PDR
40-6659

Subject: Redesign of proposed addition to the
existing Petrotomies Company Tailings
Dam, Shirley Basin, Wyoming

Job No. 5179W

Subject: Redesign of the proposed addition
to the existing Petrotomics Tailings
Dam, Shirley Basin, Wyoming

Fig. 57A

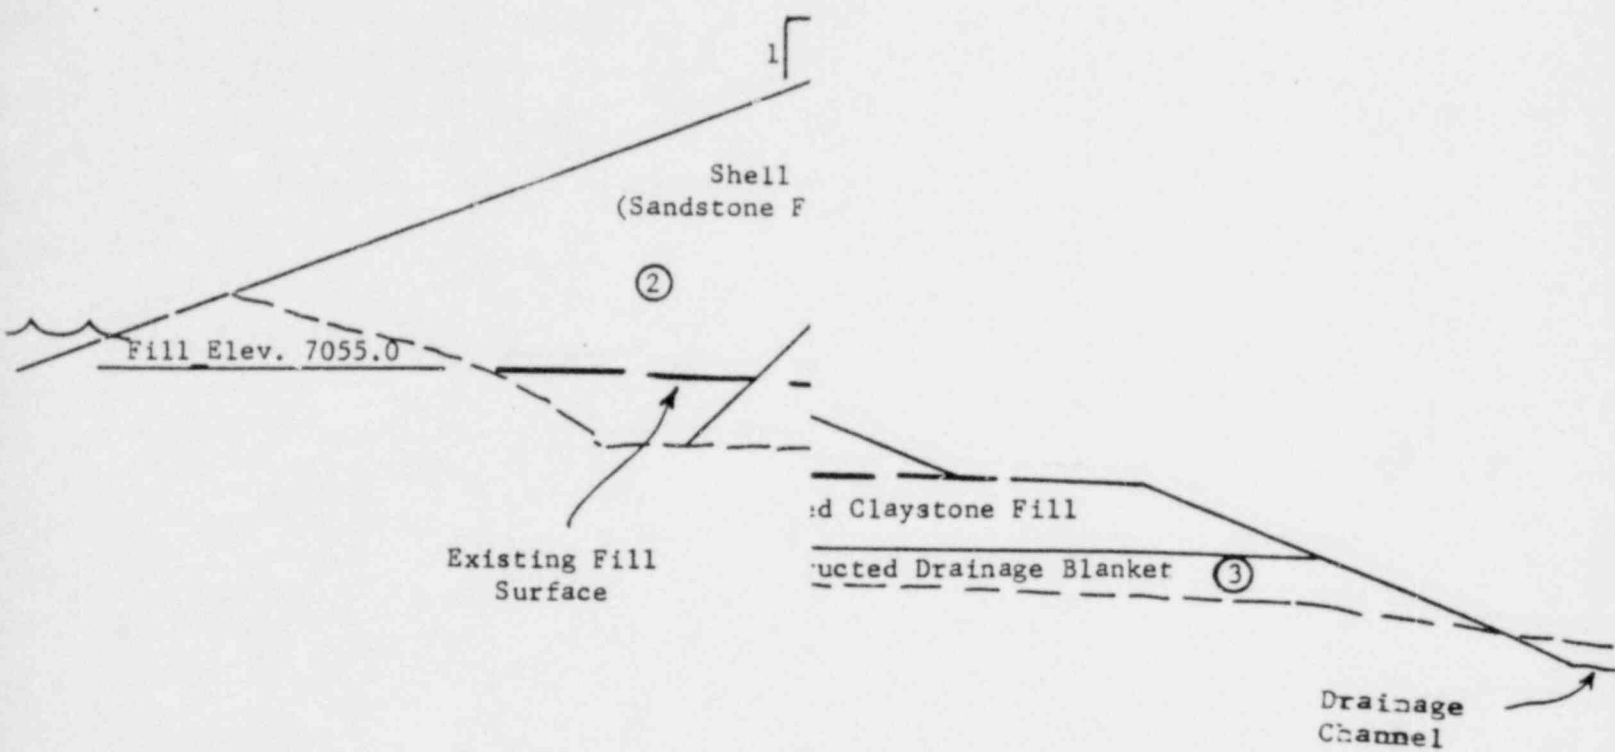
Proposed Construction: We propose that the addition to the existing Petrotonics Tailings Dam embankment be constructed as shown in Fig. 57A attached. The centerline of the dam and the slopes should be left as originally designed. The top width of the dam should be changed to 24 feet. The dam should consist of a Zone 1 interior core constructed with claystone materials from the stockpiled materials with a top width of 12 feet and 1:1 side slopes. Zone 2 upstream and downstream shells should be constructed with silty sandstone from the proposed mine area. The shells may be constructed with any of the materials sampled from the mine or dump area and tested during this program or the previous investigation. The material should be placed in 9-inch lifts at a moisture content within the range of 2.0 percent dry to 2.0 percent wet of optimum and compacted to at least 95% standard Proctor density.
